Review Comments

Project: Brighton Recovery Campus-Building E From: Jason Worthen
Project No: 20160686 Date: February 24,2017

BUILDING E RESPONSES

ELECTRICAL SITE PLAN

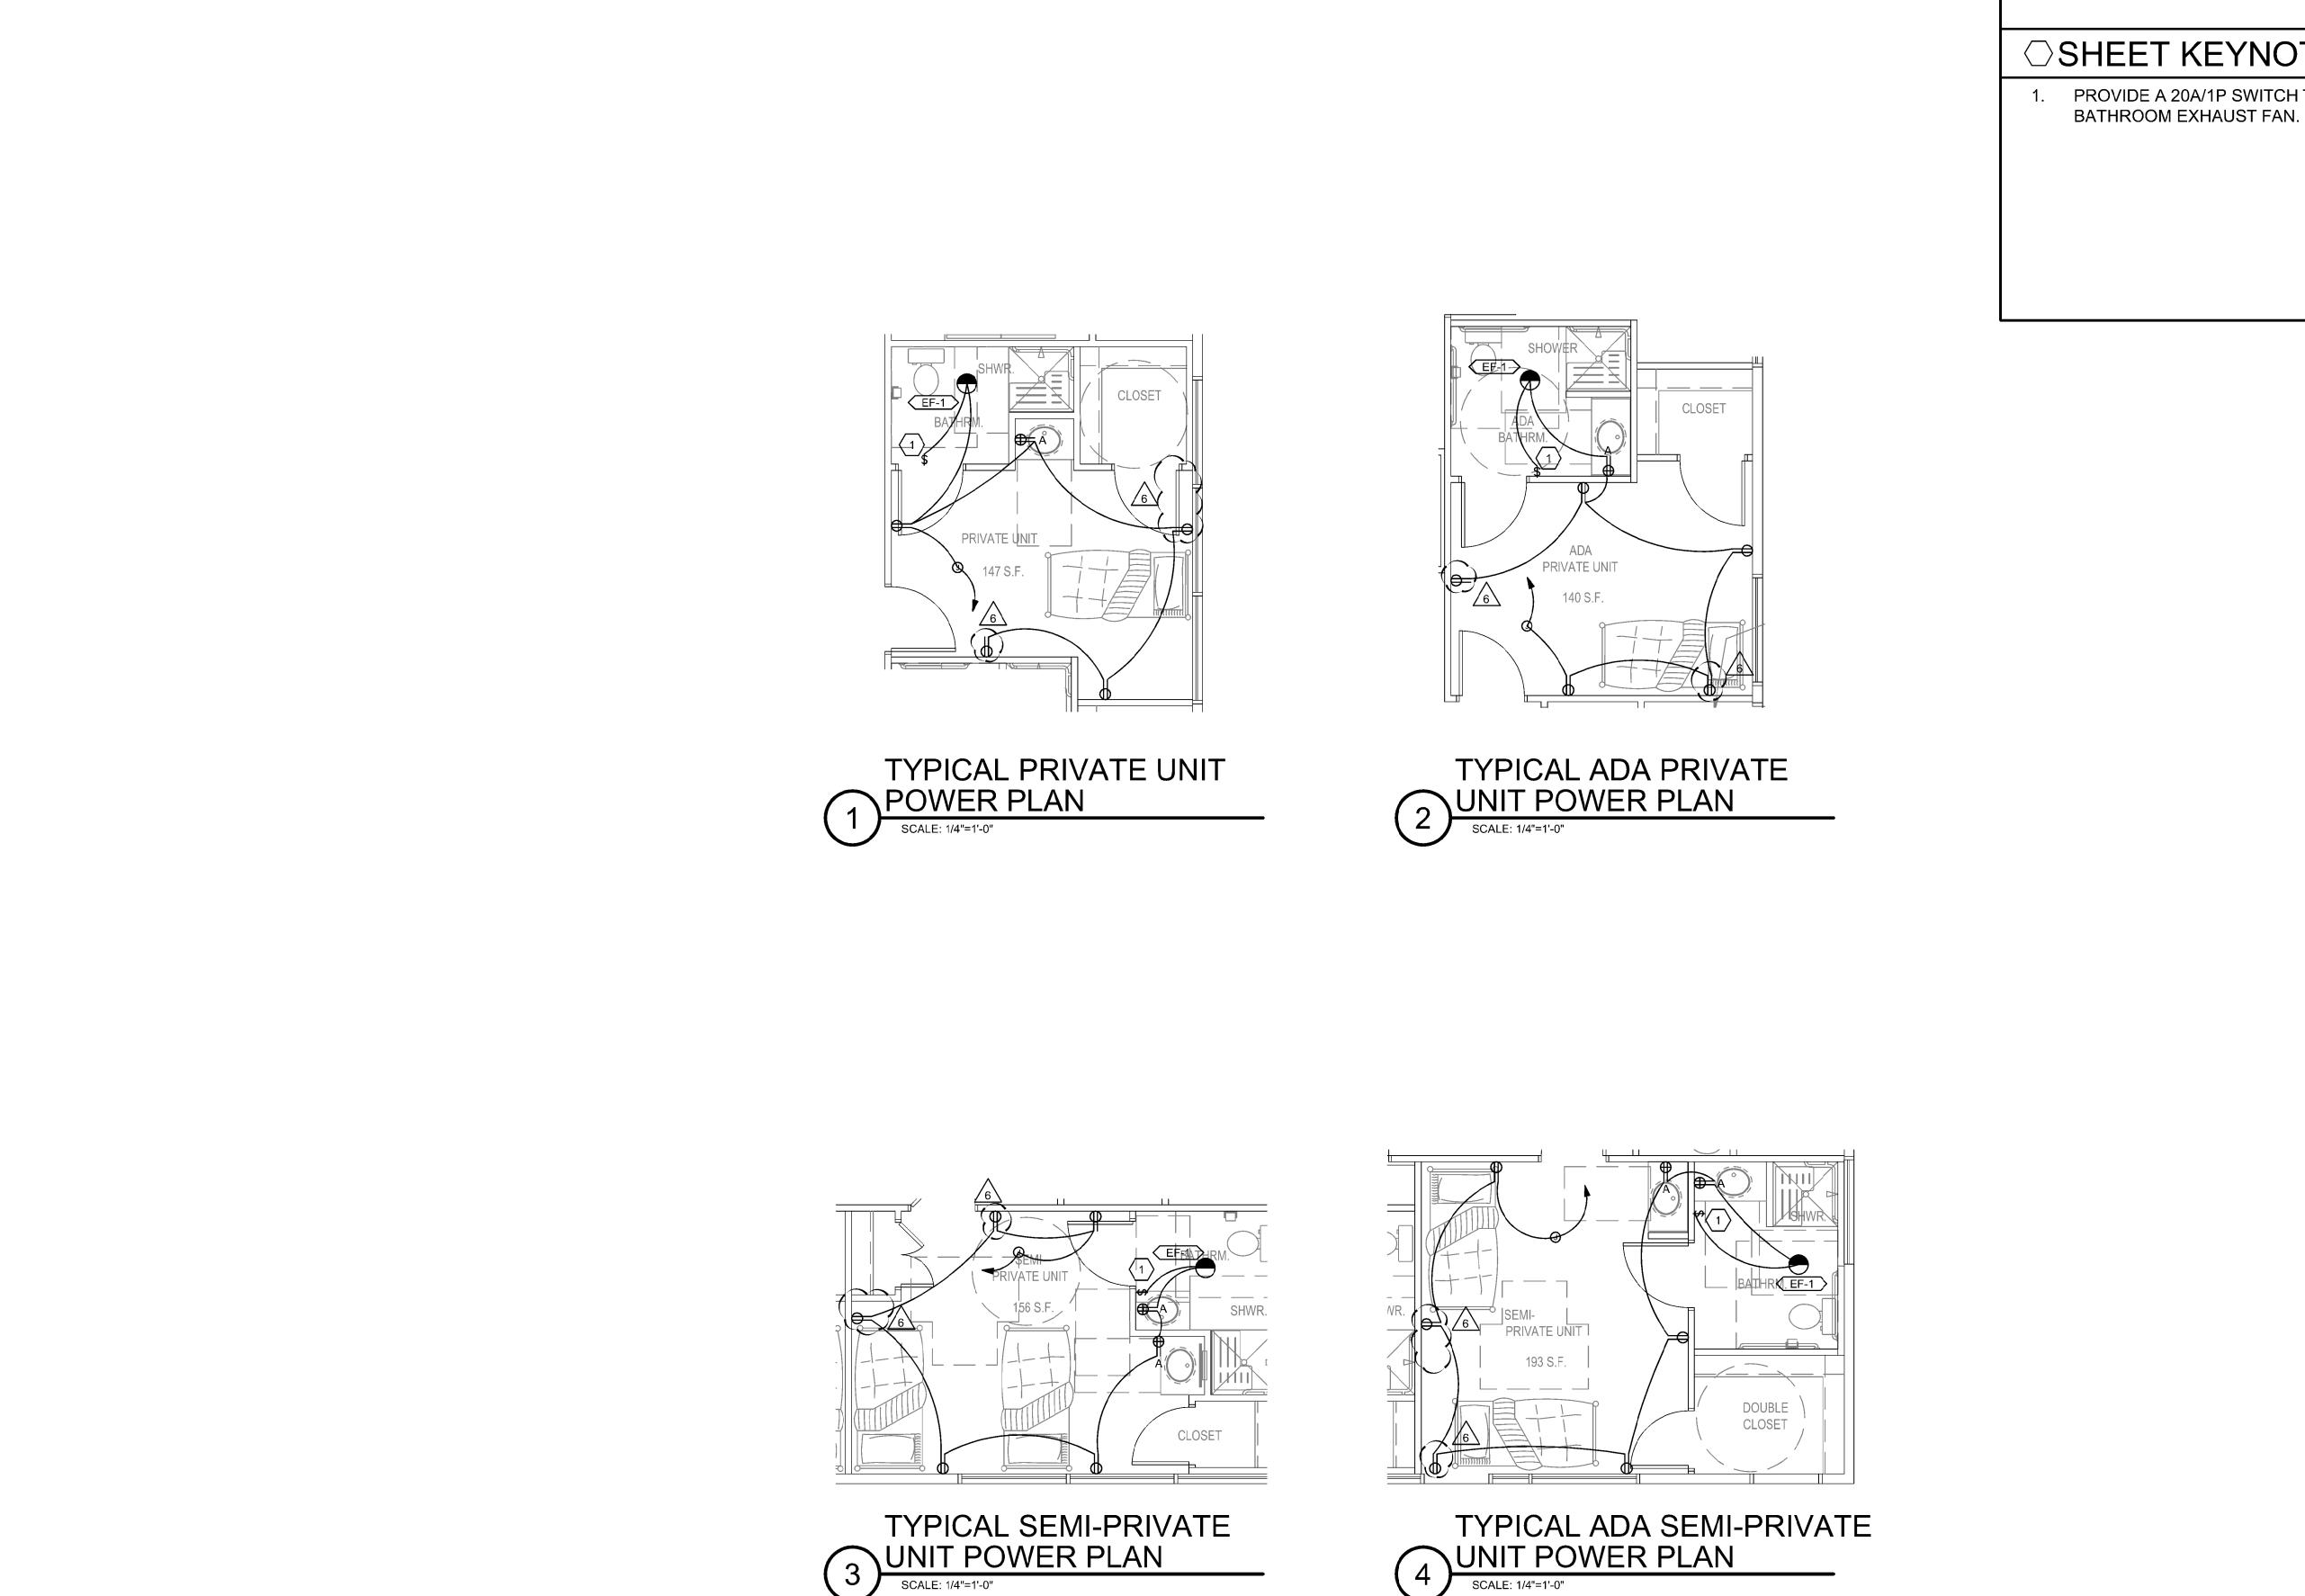
E9. Please note on electrical roof top plan WP GFCI for RTU units per NEC 210.63.

Response: Provided 120 volt circuit to all rooftop units for GFI WP receptacle that will be provided with unit.

TYPICAL POWER PLANS

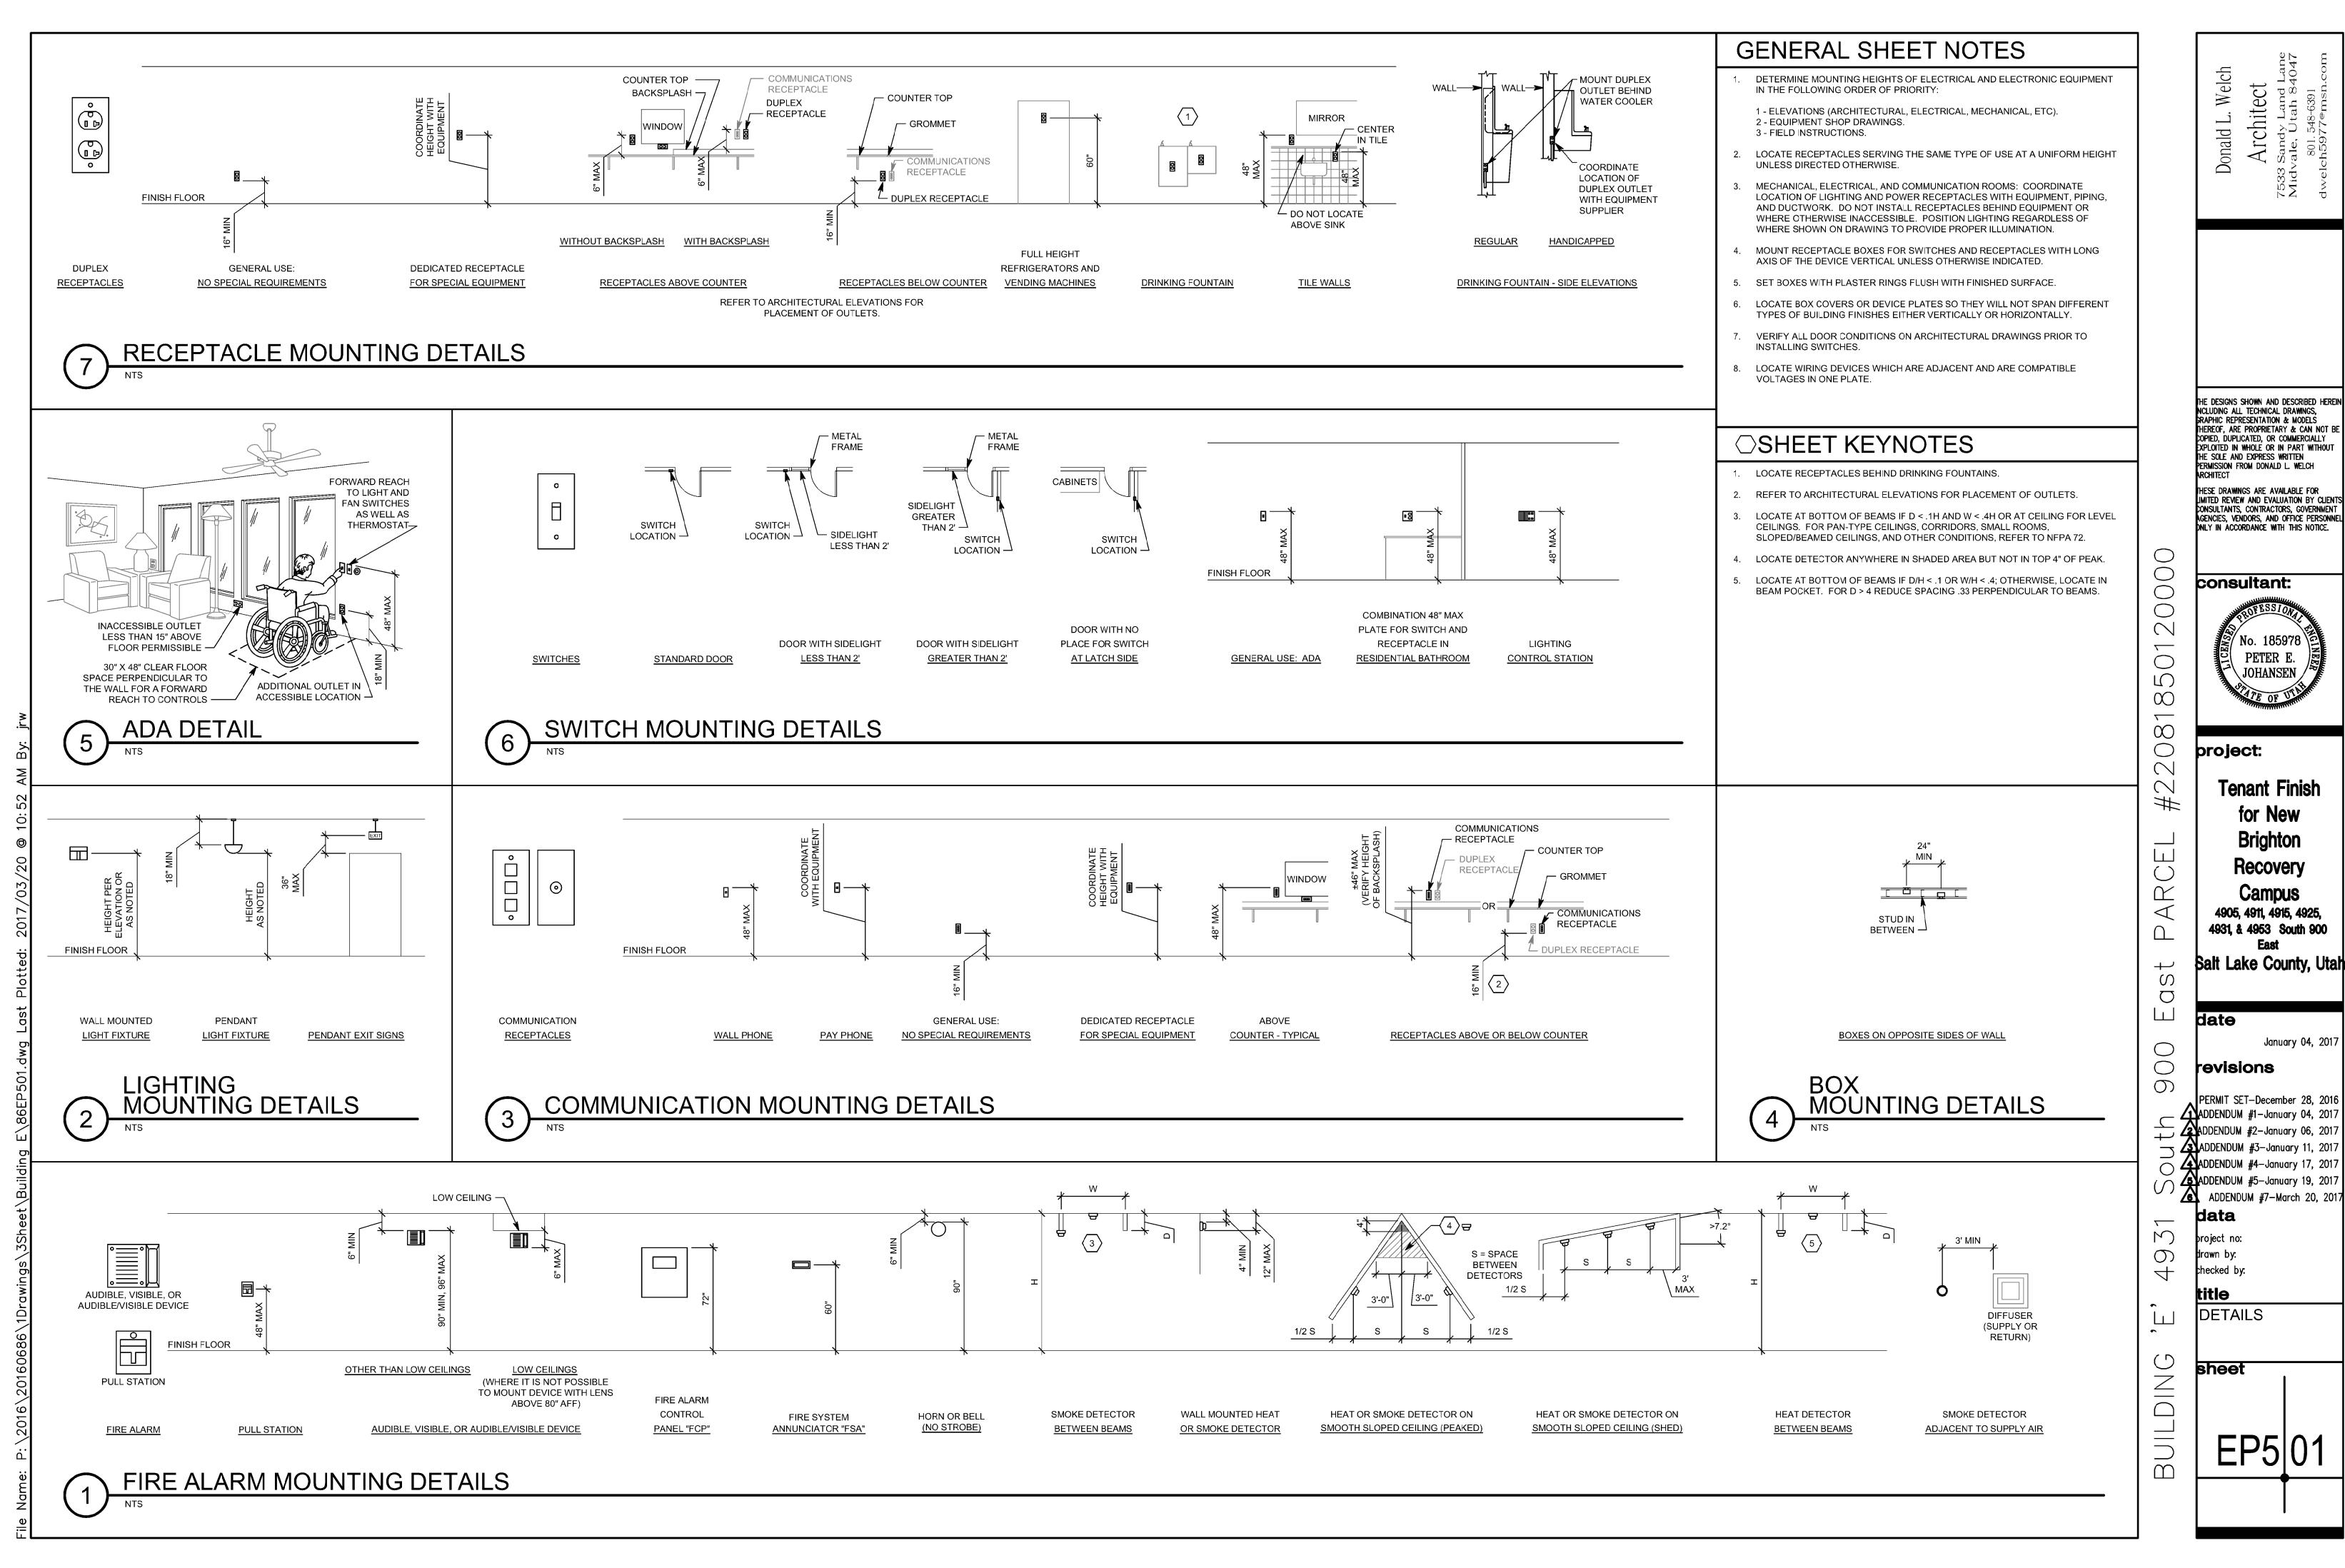
E6. Sheet EP401: Please address the following: Receptacle outlet spacing in guest, rooms, guest suites, and similar occupancies shall conform to NEC Article 210.60A.

Response: Details 1,3&4: Relocated one receptacle and added one receptacle in order to meet spacing requirements. Details 2: Relocated one receptacle and added two receptacles in order to meet spacing requirements.

EP401 (see attached sheet)

- 1. Added a general note requiring all receptacles to be tamper resistant.
- 2. Detail 1:
 - a. Moved duplex receptacle near closet door to the outer wall.
 - b. Added a duplex receptacle on the bottom wall.
- 3. Detail 2:
 - a. Added one duplex receptacle on the top wall.
 - b. Relocated duplex receptacle on the wall shared with the closet to the left wall.
- 4. Detail 4:

- a. Moved duplex receptacle on the left wall at the foot of the bed closer to the
 - b. Added a duplex receptacle on the bottom wall.
